Public Comment for Administrative Record
Re: Council File # 05-0173
Glendale Boulevard-Hyperion Avenue Complex of Bridges
Improvement Project California Environmental
The Proposed Bike Lanes for Hyperion Bridge

Council File No. 05-0173

RESPONSE TO THE TECHNICAL MEMORANDUM ON BICYCLE AND PEDESTRIAN FACILITIES ASSESSMENT

To: City of Los Angeles Bureau of Engineering
From: Alejandro Angel, PhD, PE, PTOE and Arief Naftali, PE, TE
cc: Anissa Voyiatzes, PE
Date: May 28, 2015
Re: Bicycle and Pedestrian Facilities Assessment

Figure 1: Hyperion Avenue Bridge over I-5, Riverside Drive and LA River (Looking North)

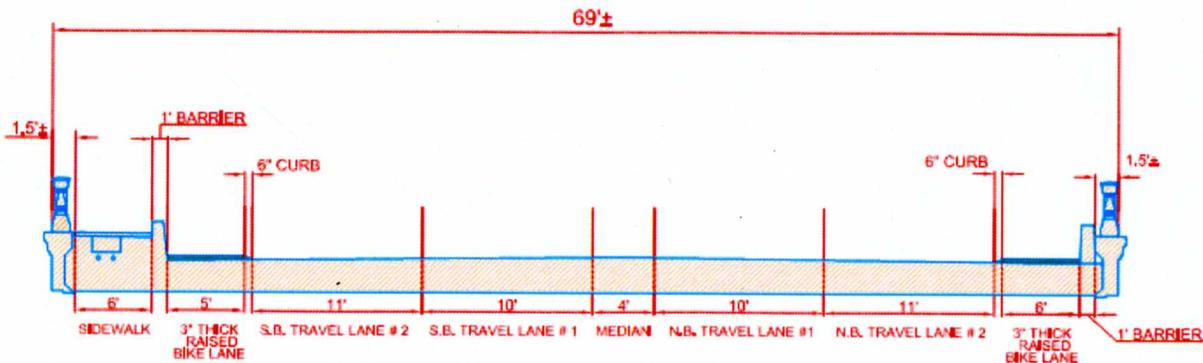
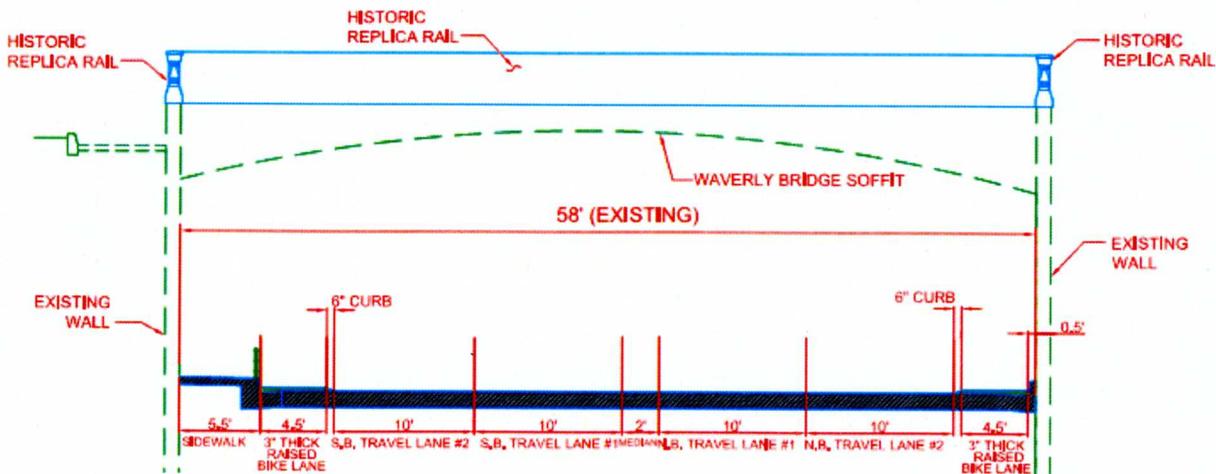
Improvements in the TM's recommended option (attachment) fail to minimize or eliminate the certain key bicycle and pedestrian safety risk factors.

1. While the new six-foot sidewalk along the west side of Hyperion Ave over I-5 and the Los Angeles River provides ADA compliant PAR on one side of the bridge, it fails to provide a PAR for pedestrian on the opposite of the bridge thereby adding a ½ mile of pedestrian travel distance.

The disadvantages in the TM's recommended improvements are based on incorrect assumptions and miscalculations. By having a sidewalk on only one side of the road, there is a significant safety risk of conflicts between bicyclists and pedestrians walking on the bike lane along the east side of Hyperion Avenue between Waverly and Glenfeliz/Glenhurst .

Figure 4 Comparison of Existing and Proposed Pedestrian Facilities

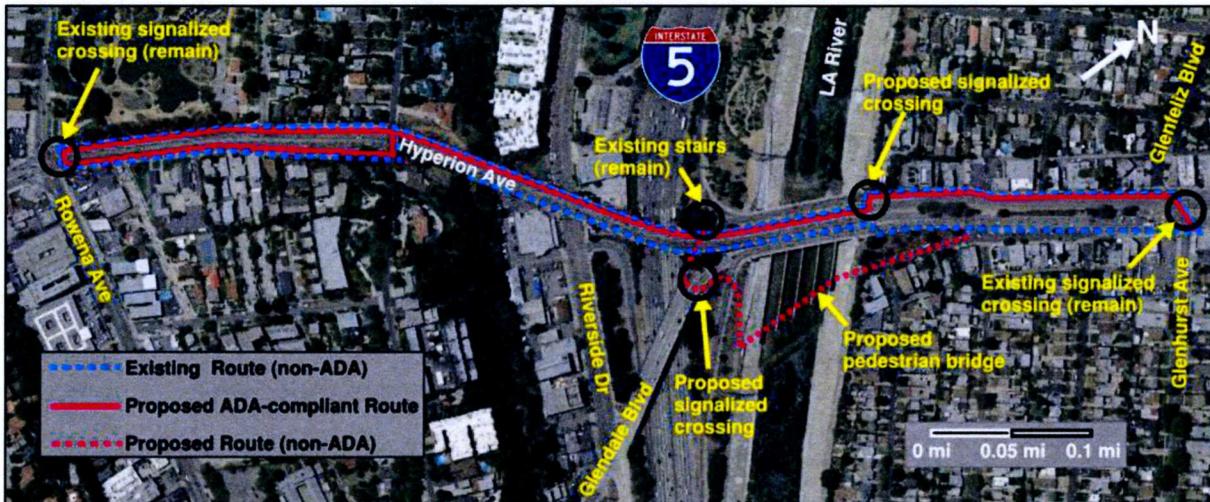
3. Longer travel paths for pedestrians starting or ending their trips on the east-side of Glendale Blvd between the Los Angeles River and Glenhurst Ave exist. The disadvantages listed in the TM incorrectly minimize the estimates of travel times for both able-bodied and disabled pedestrians. It fails to recognize that much of the pedestrian activity will be on a significant grade. Assuming the travel distances are correctly indicated in the TM, the significant travel time impacts on pedestrians are more correctly reflected as shown.

- Able-bodied: Longer travel time of 2.6 minutes at 2 ft/s walking speed for 310 ft distance.
 - Disabled: Longer travel time of 17.2 minutes at 1.5 ft/s for 1550 ft distance. This travel time can be compounded due to the 5 percent grade in the Atwater to Silver Lake travel path.
